# Belvac Production Machinery Technical Bulletin

ISSUE 2, VOLUME 21, AUGUST 2018

## STAINLESS REFLECTORS

**STAINLESS STEEL REFLECTOR**

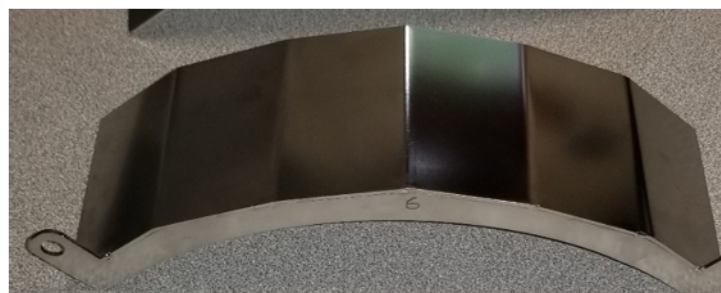
Testing has conclusively proven the BV40 series Light Tester provides an opportunity to replace the copper plated reflectors typically associated with Light Testers with a more robust stainless steel version.

Stainless steel reflectors will be more resistant to deformation during can jams, less susceptible to scratching and oxidation, and still provide leak detection exceeding minimum standards by 300% or more.

Stainless steel reflectors will be standard on all Belvac Light Tester turrets shipped after October 01, 2018.
